## MONITORING YEAR 3

### MOORES FORK STREAM MITIGATION PROJECT

Wildlands Engineering, Inc. (Wildlands) has reviewed the Division of Mitigation Services (DMS) comments from the Draft Monitoring Year 3 report for the Moores Fork Stream Mitigation Project. The following Wildlands responses to DMS's report comments are noted in italics lettering.

Survey Date: 06/2018  
Field Crew: Kee Mapping & Surveying

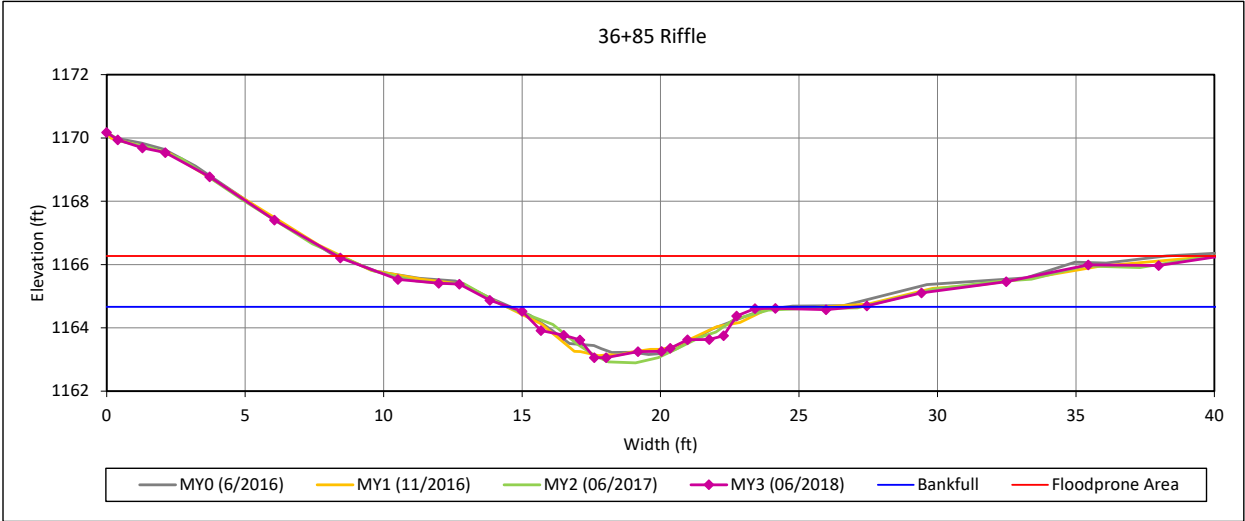
**DMS comment; Cross-sections: Please turn off markers for all years except MY3.**

*Wildlands response; All markers have been turned off except for MY3 on cross-section plots.*
